**Project Name:** \* Bridge 9 over South River on US 13

B-4635

Subject: **Request for Additional Information for T.I.P. B-4635 (Replacement of Bridge 9 over South River Overflow on US 13, Sampson County)**

-DET-

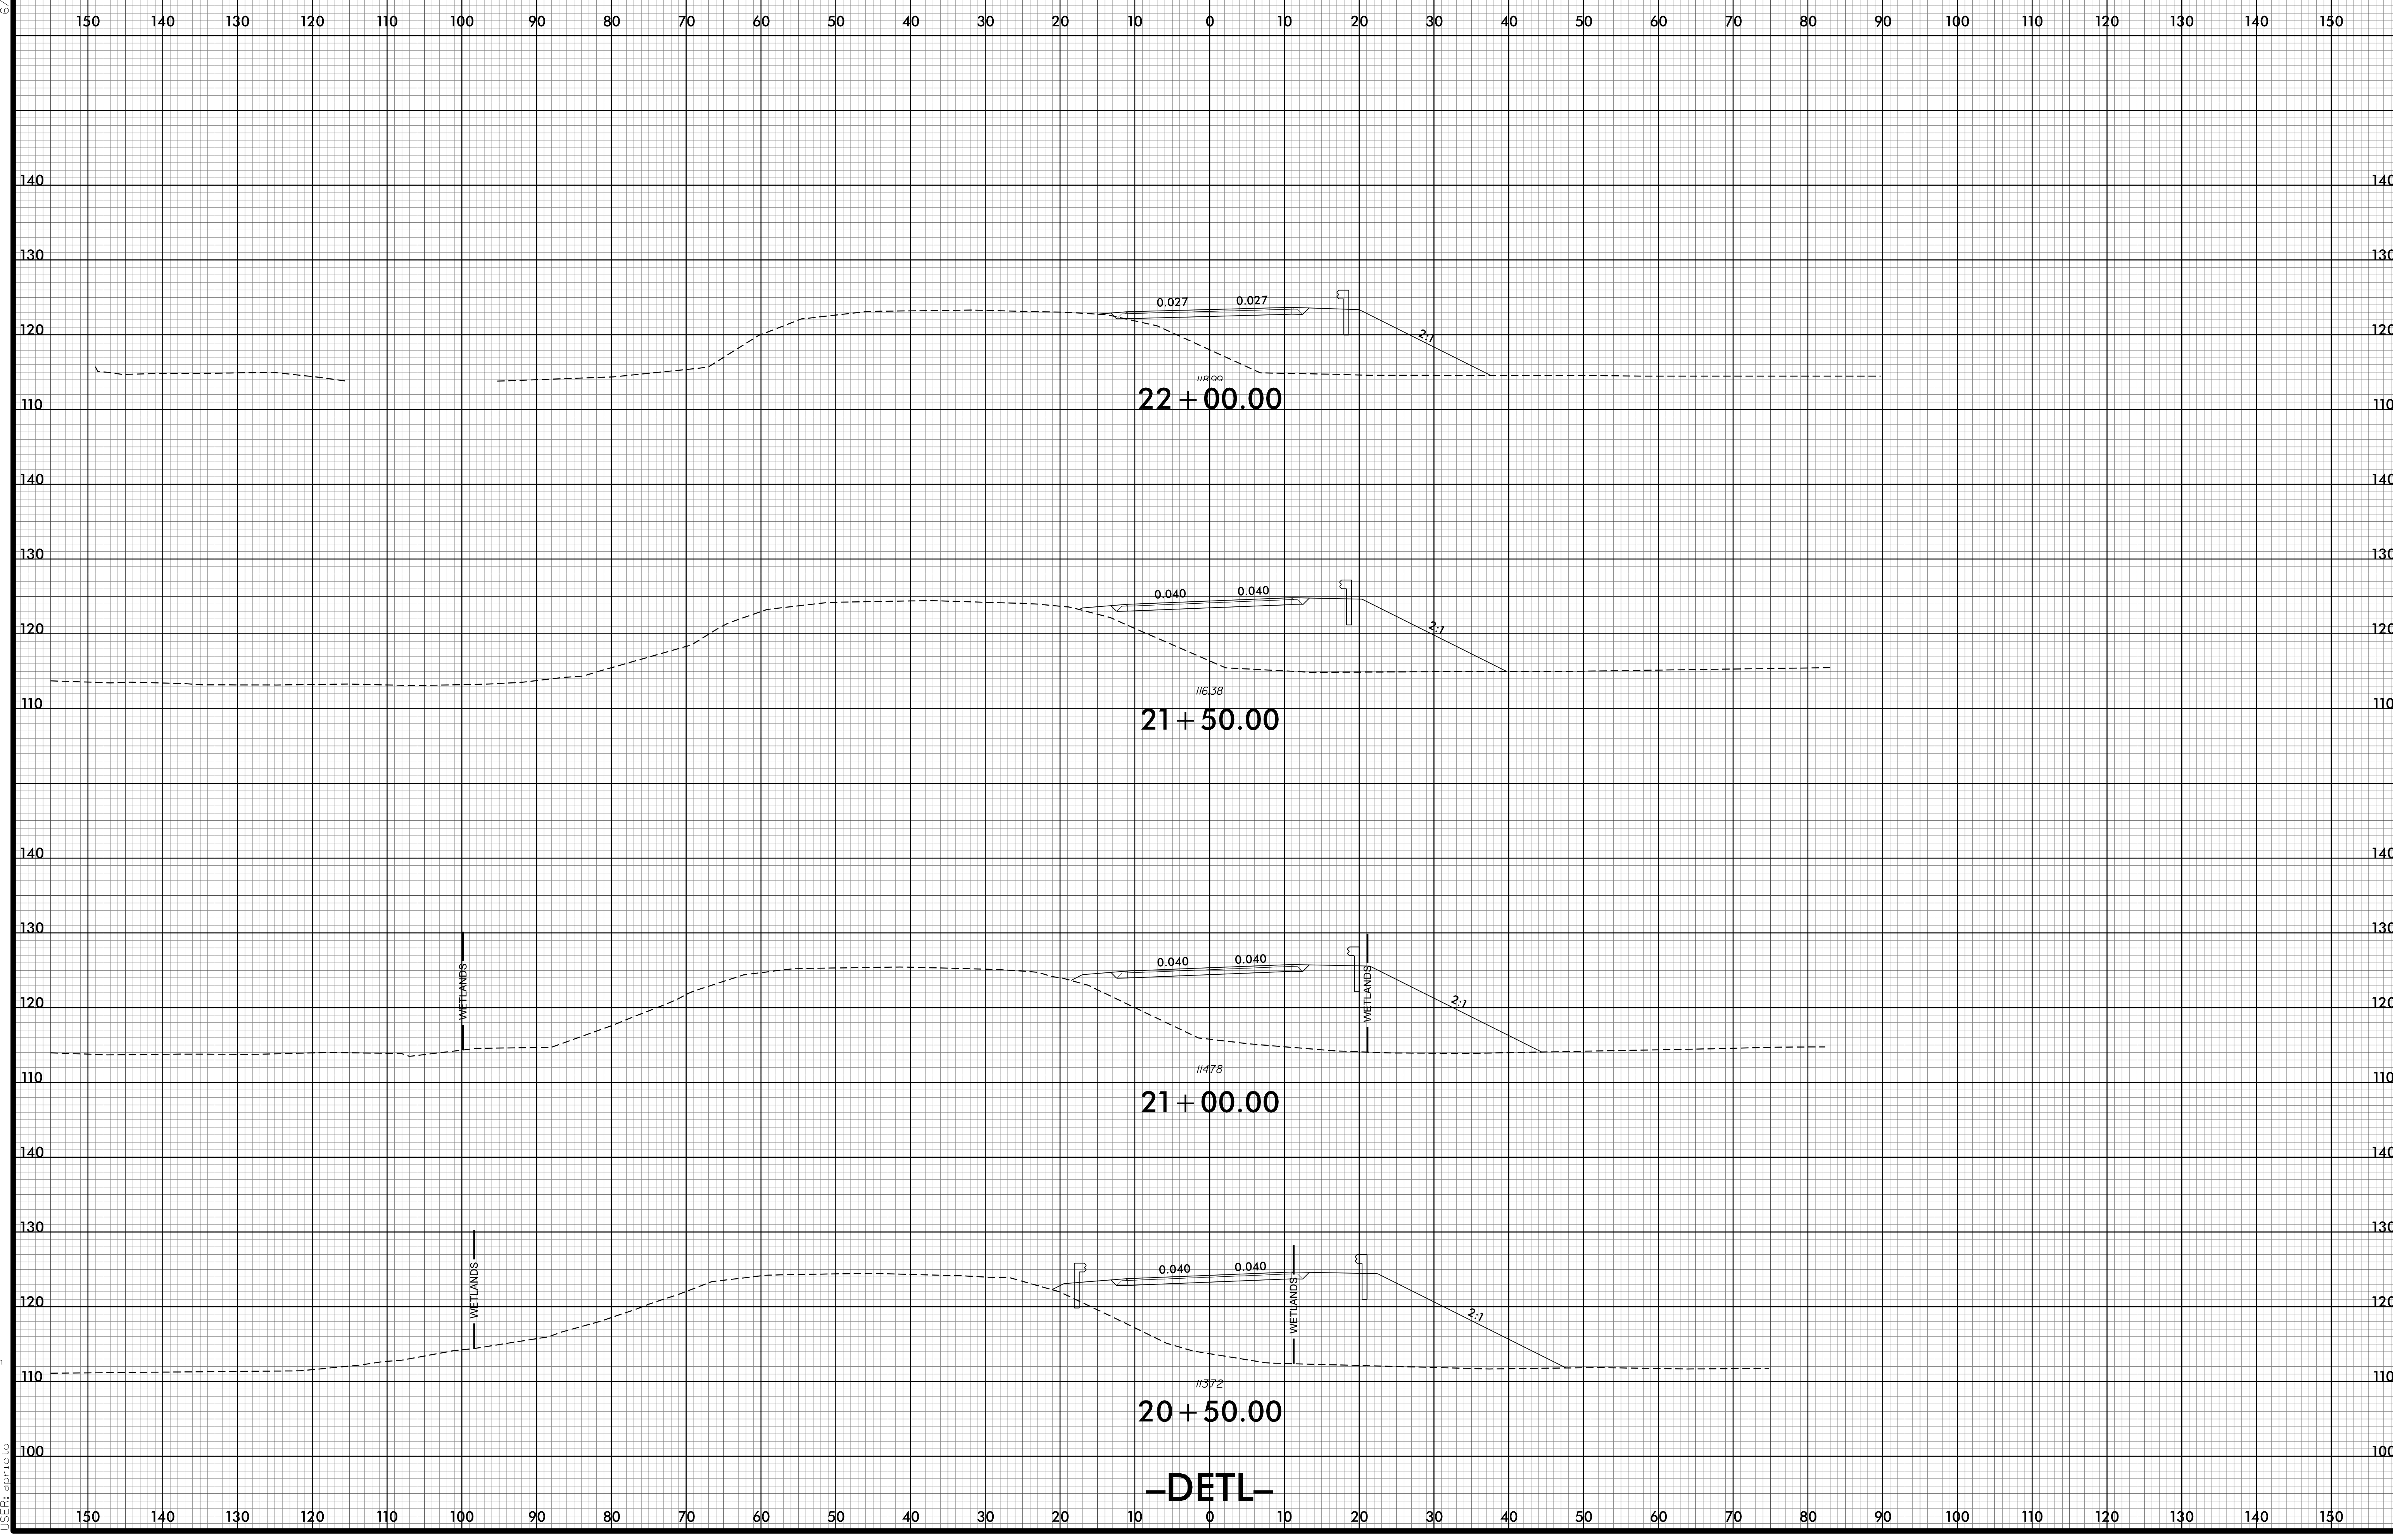
-there is no slope listed in the cross section drawings regarding the temp detour which leads to the question, could the slope be steeper than 3:1 since it would most likely be constructed with a rock base thus reducing the amount of temporary impact? **Cross sections of the detour are included in revised drawings to show 2:1 slopes along the detour.**
